CITY OF ALBUQUERQUE

PLANNING DEPARTMENT – Development Review Services

**RE: Western United Electric
Conceptual Grading and Drainage Plan
Engineer's Stamp Date 8-9-2015 (H10D029)**

WESTERN UNITED ELECTRIC
GRADING AND DRAINAGE PLAN

SIDEWALK CULVERT CALCULATIONS

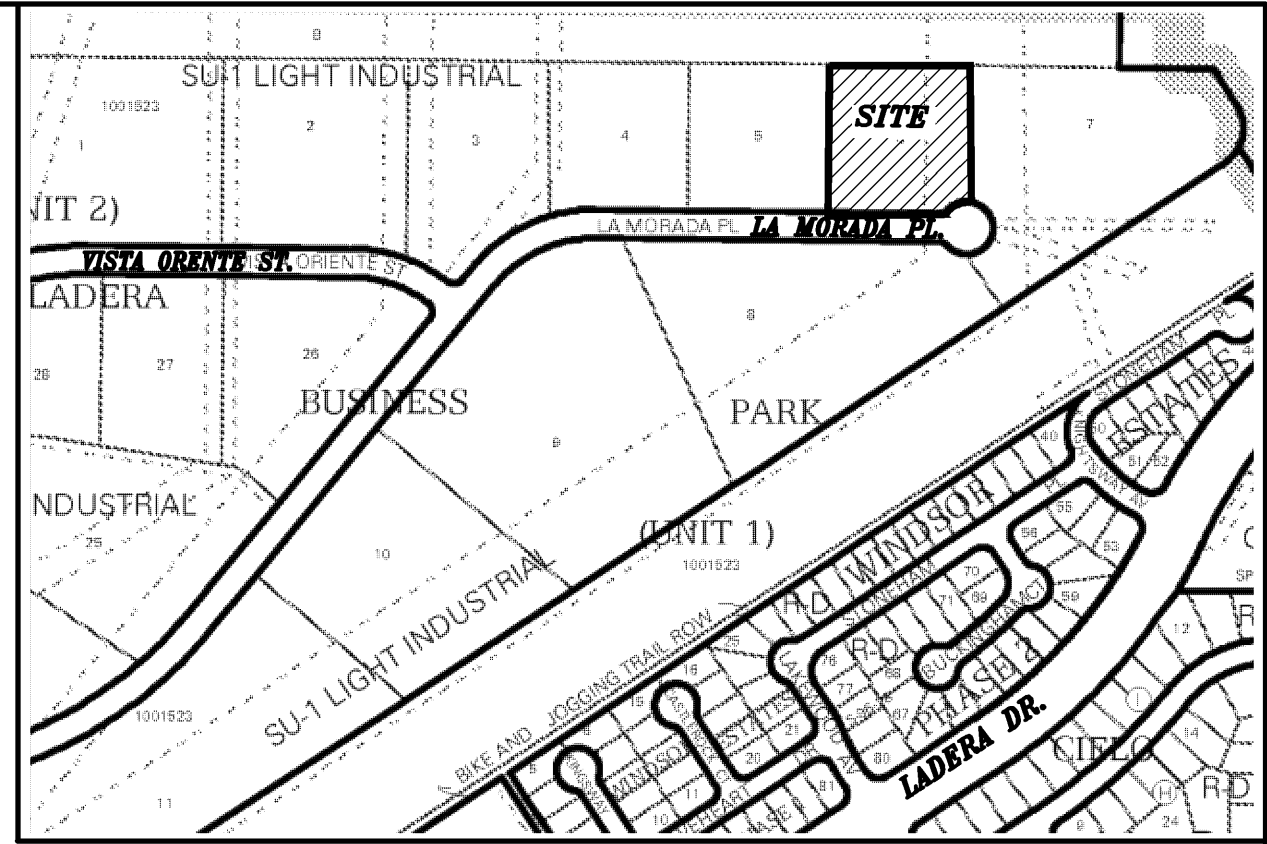
5. How are flows from Pond A getting to Pond B? Show a channel or swale and a section cut.
6. SW culverts are sized using the orifice equation but they are above the pond. Use the weir equation.
